Access Compliance Report

Public Rights-of-Way

(Curb Ramps)

Intersection ID: 10617	Main Street: STATE_ST	Cross Street: WHITEHAVEN_AV	Location: NE
ADA ID: 4305738F21CA	Ramp Type: PerpDiag	Initial Pass/Fail: Fail	Overall Compliance: No
Severity Score: 36.25			
Codes/Mitigation Info/Possible Solution		Field Measurements/Component Compliance

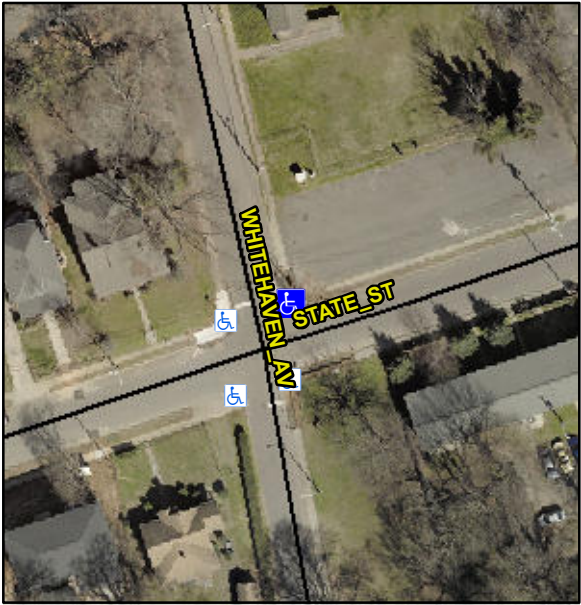
Possible Solutions:	Compliance	Description	Data	Compliance	Description	Data
	Remove & Replace Curb Ramp With Two New Directional Ramps or Equivalent.	N/A	Ramp Length (in)	64.0	Yes	Ramp Slope (%)	5.2
<p>Surveyor Notes:</p> <p>N/A</p> <p>PROW/ADA:</p> <p>Not Found, R304.5.1, R304.5.3</p>		No	Ramp Width (in)	24.0	No	Ramp XSlope (%)	2.6
		N/A	Flare Type LT	N/A	N/A	Flare Type RT	N/A
<p>Street 1 Name</p> <p>WHITEHAVEN AV</p> <p>Stop Condition-Street 2</p> <p>StopSign</p> <p>Street 2 Name</p> <p>STATE ST</p> <p>Stop Condition-Street 1</p> <p>None</p>		N/A	Flare Slope LT (%)	N/A	N/A	Flare Slope RT (%)	N/A
		N/A	Flare Traversable LT?	N/A	N/A	Flare Traversable RT?	N/A
<p>Total Cost:</p> <p>\$ 3200.00</p>		N/A	Landing Length (in)	N/A	N/A	DWS Provided?	N/A
		N/A	Landing Width (in)	N/A	N/A	DWS Contrast?	N/A
		N/A	Landing Slope (%)	N/A	N/A	DWS Length (in)	N/A
		N/A	Landing X Slope (%)	N/A	N/A	DWS Full Width?	N/A

N/A	Landing Curb? (Y/N)	N/A	N/A	DWS Offset (in)	N/A
		N/A	Shared Landing?	N/A			
		N/A	Gutter Ponding?	N/A	N/A	Gutter Slope (%)	N/A
		N/A	Gutter Lip Ht (in)	N/A	N/A	Gutter X Slope (%)	N/A
		N/A	Painted X Walk1?	No	N/A	Painted X Walk2?	No
			X Walk 1 Direction	To W		X Walk 2 Direction	To S
		N/A	X Walk 1 Width (in)	N/A	N/A	X Walk 2 Width (in)	N/A
			X Walk 1 Slope (%)	8.1		X Walk 2 Slope (%)	3.5
			X Walk 1 X Slope (%)	4.6		X Walk 2 X Slope (%)	5.0
		N/A	Ramp inside XWalk1?	N/A	N/A	Ramp inside XWalk2?	N/A
			Road Slope (%)	4.2	N/A	Clear Space?	N/A
			Road X Slope (%)	6.6	N/A	Clear Space to XWalk (in)	N/A
		N/A	Any Obstructions?	N/A	N/A	Storm Grate/Utility Hazard?	N/A
			Obstruction Type			Storm Grate/Utility Type	
					N/A		N/A
					Yes	Surface Condition? (G/P)	Good
